SERVICE BULLETIN

SB-10056647-1505

SUBJECT : Changing the route of steering oil line

SUMMARY : This bulletin is purposed to change the steering oil line routing.

Fig. 1

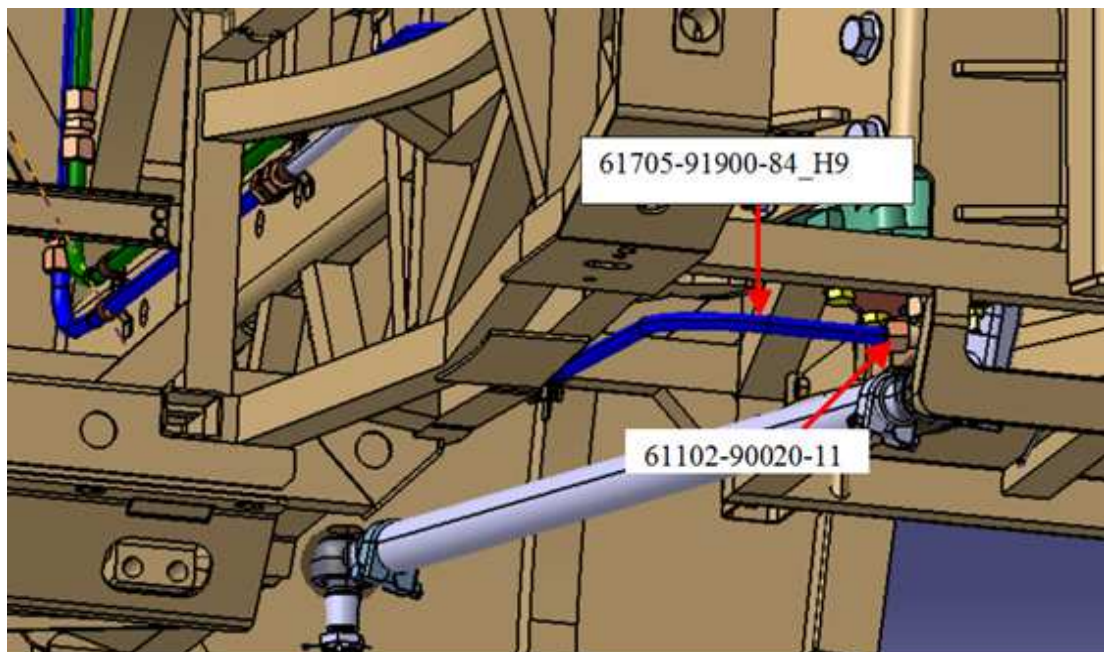
1. First of all drain the oil in the steering oil line safely. Dismount the connector(61102-90020-11) is shown in the figure.

Fig. 2

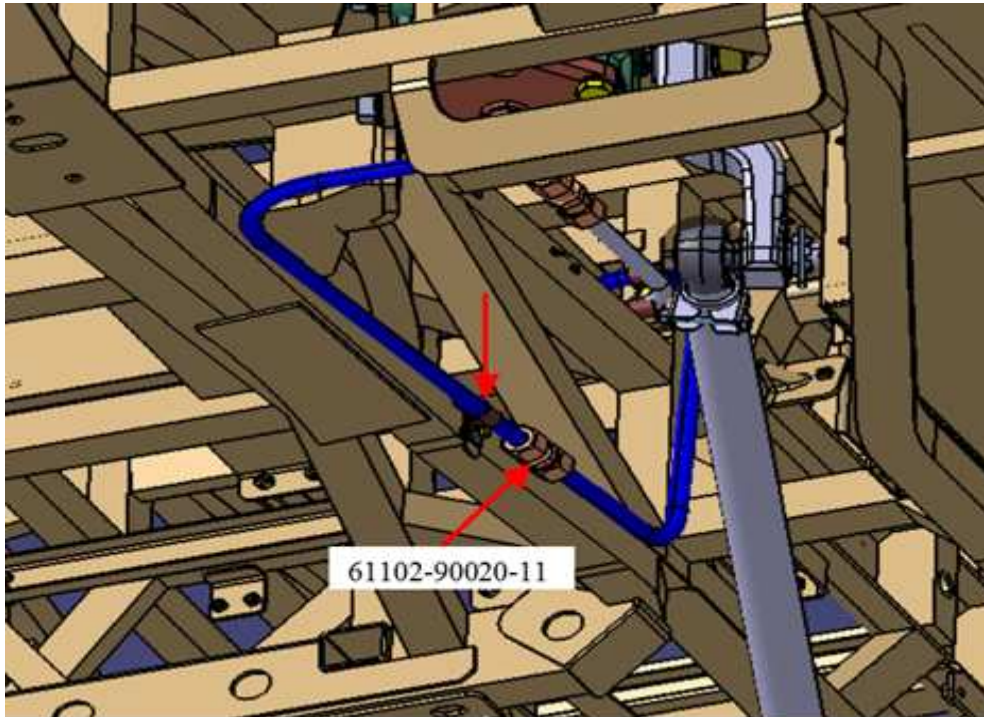
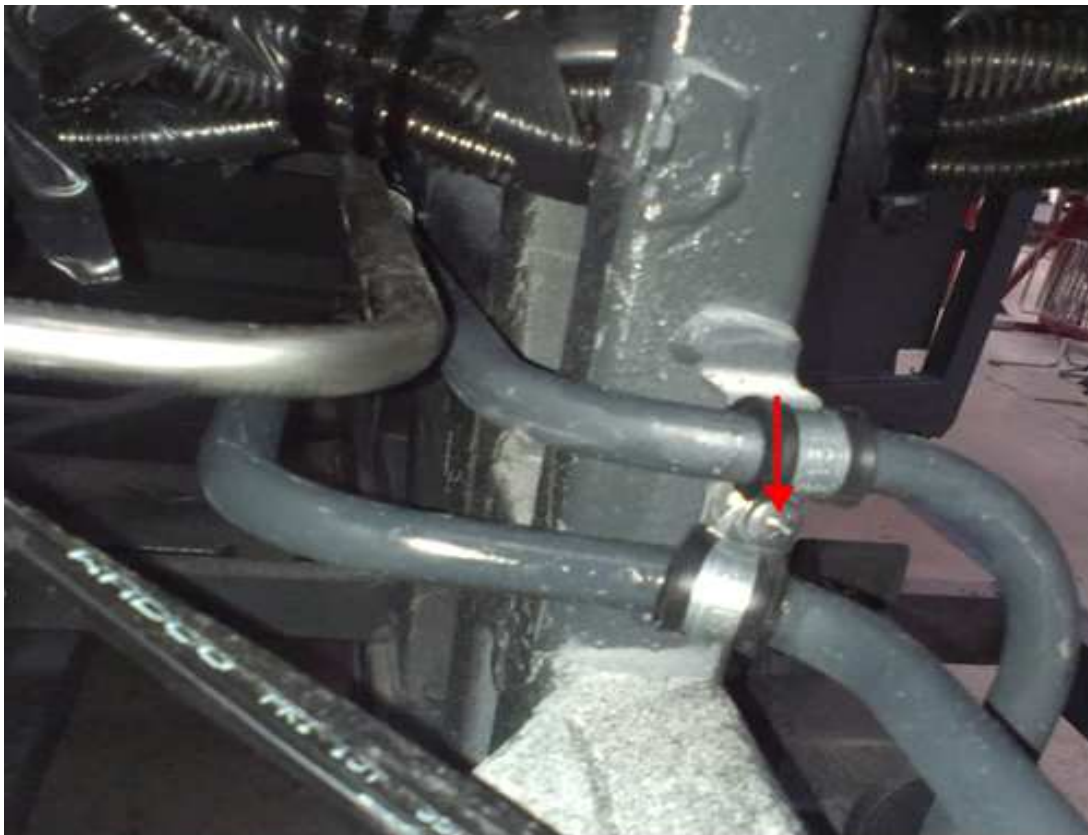
2. Dismount the connector at the end of the pipe (61705-91900-84_H9) and dismount the clips as shown in the figure. Remove the pipe (61705-91900-84_H9).

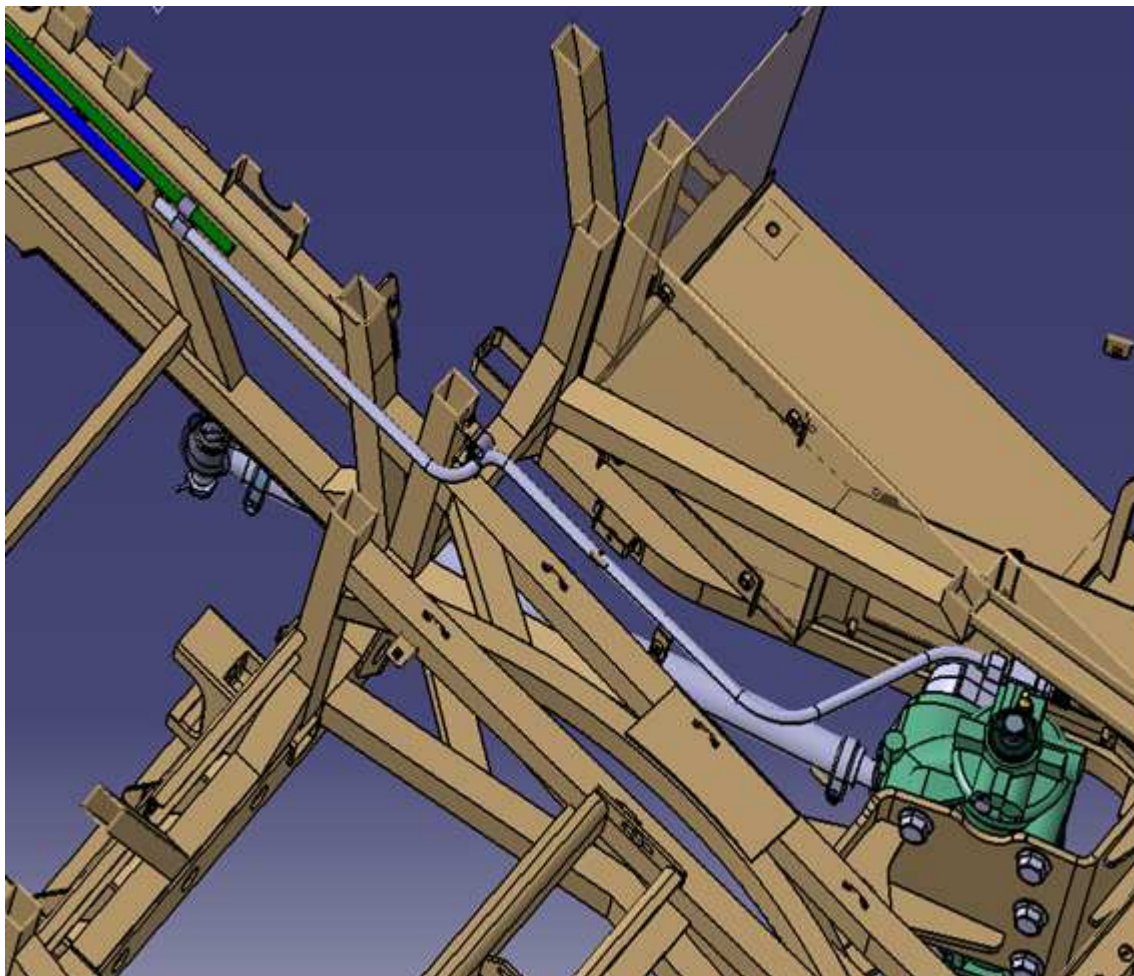
3. Dismount the clips is shown figure.

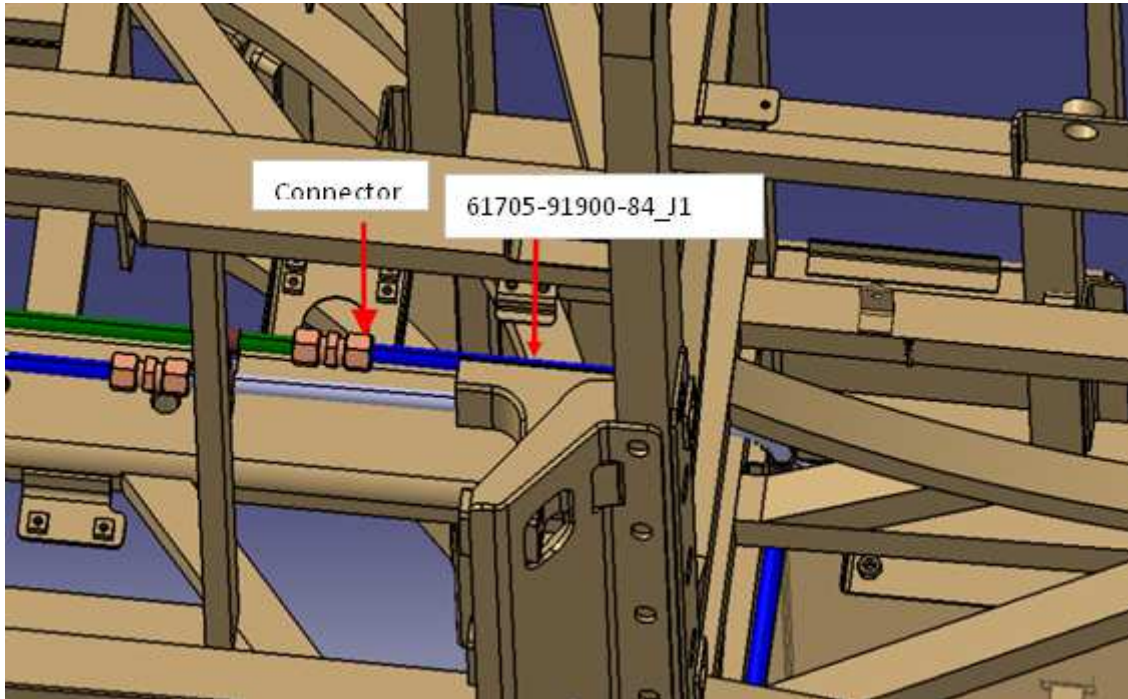
4. Dismount the connector at the end of the pipe (61705-91900-84_J1)

5. Attached the pipe the line by using the connector.

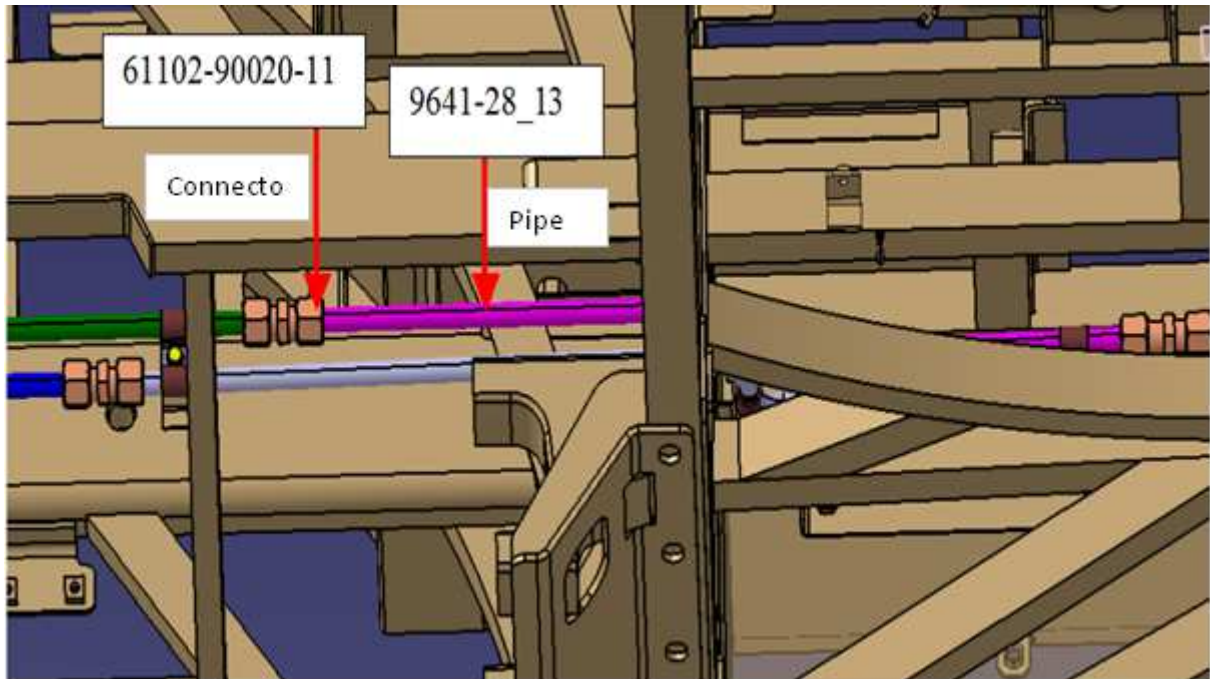
6. Fix the pipes by using clips.

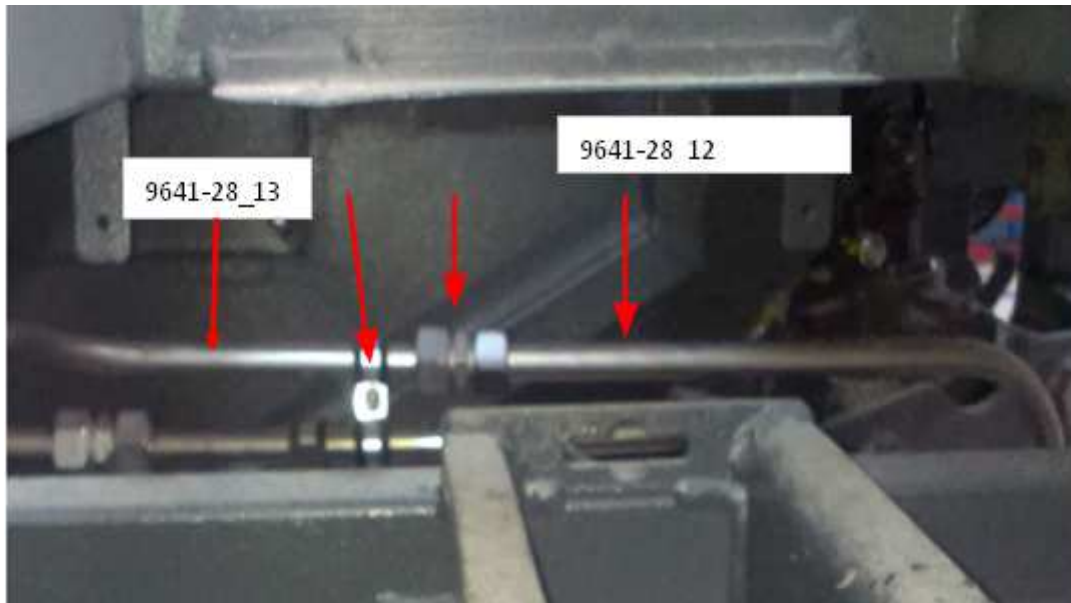
7. Attached the pipes to the line as shown in figure.

8. Attached the pipe to the connector of steering gearbox.

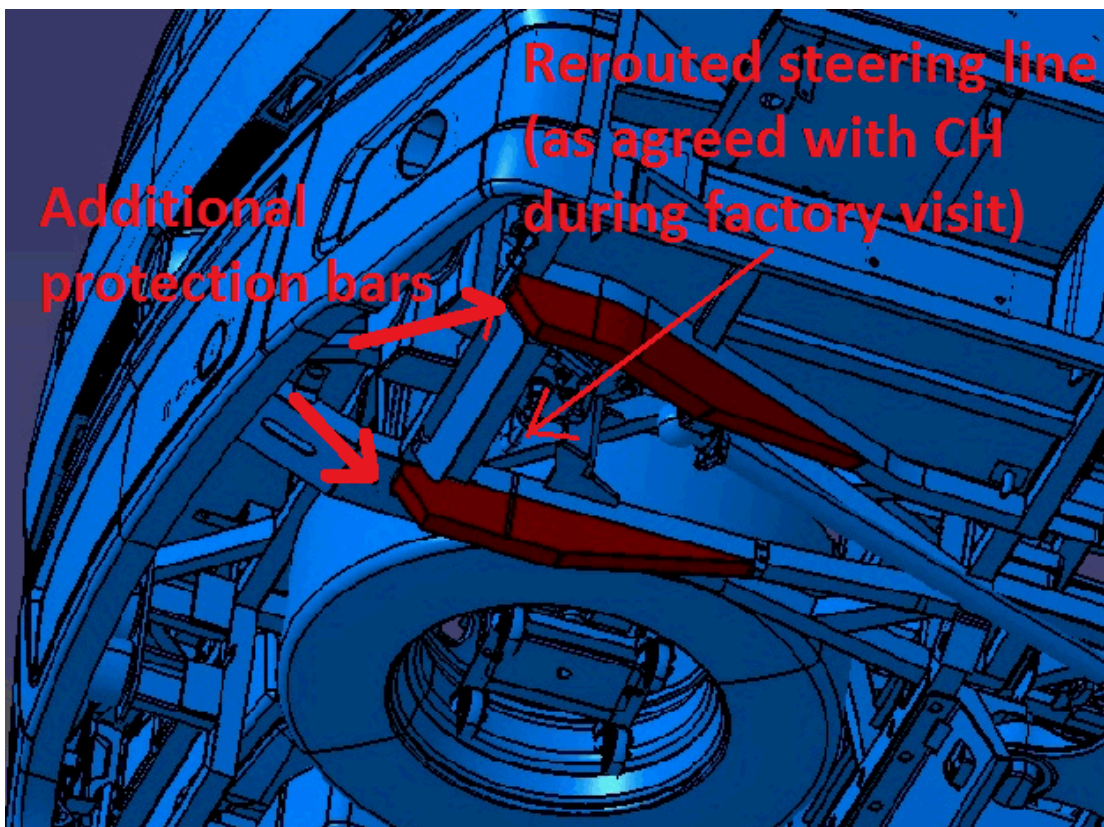
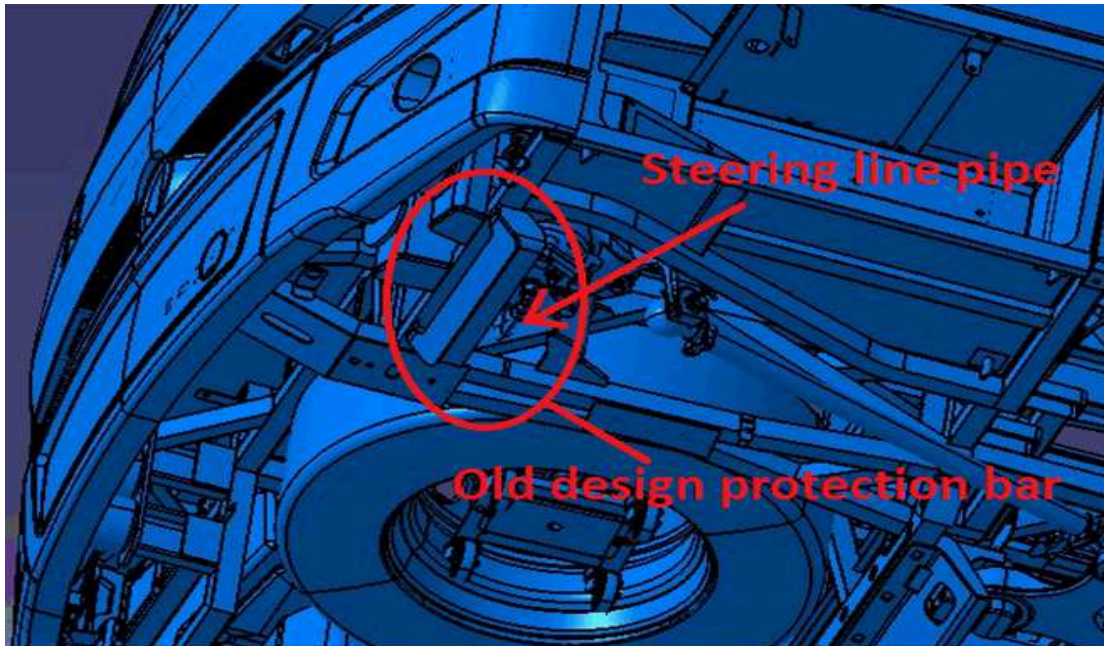
9. Weld the profiles (9301-10102Y and 9301-10104Y) next to the both sides of existing protection bars shown in below
